Product /Process Change Notification

Lite-On would like to replace the lead frames of the LTST-A683 & LTST-E682 & LTST-E683 & LTST-E683C & LTST-N682 & LTST-N683.

LTST-A683 series	
Old lead frame (10L683-1 / -2)	New Lead frame (10L683-D)

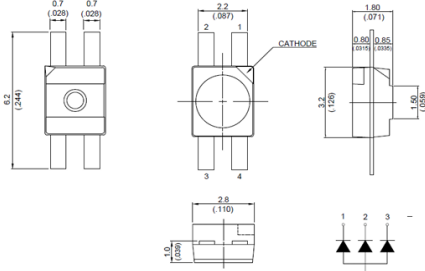
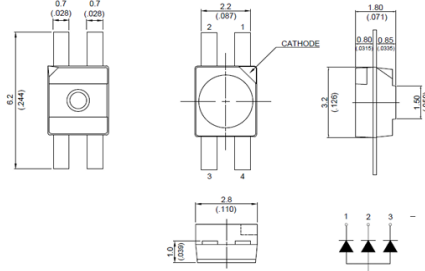
For business continue plan, add Lead Frame PPA type TA105 which supplier was the same with TA112, we will conduct lead frame replacement as shown below.
